S4.55 SCHEDULE OF MODIFICATIONS:

SECTION 4.55 MODIFICATION

Title:
Cover Sheet

Project:
Newquest - Seniors Development
1 Drew Place, Belrose

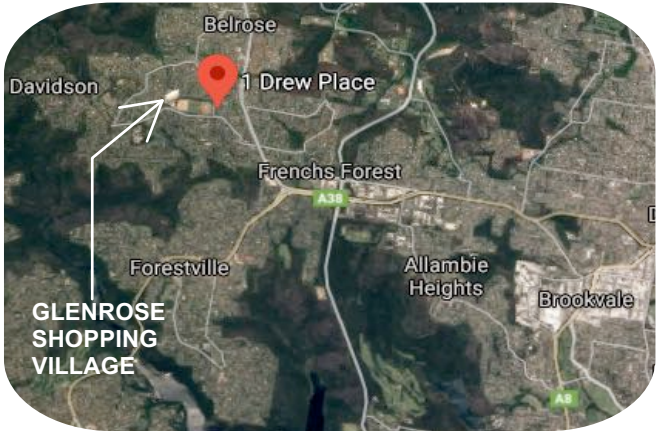
1. Western wing metal roof pitch increased from 5 to 14°, increasing ridge height to still be below main ridge height of 171.3AHD
- 2

2. Small sections of metal roof below dutch gables removed and gables extended to be flush with breezeway roof
- 3

3. Gable addition to Unit 6 to better integrate with breezeway roof
- 4

4. Lift overrun protrudes through breezeway roof
- 5

5. Roof pitch to Unit 3 increased from 12 to 20°
- 6

6. Unit 6 windows to study and bathroom have been relocated and slightly reduced in size
- 7

7. Polycarbonate roof sheeting to DA approved pergolas
- 8

8. Additional timber pergola with polycarb sheet roofing
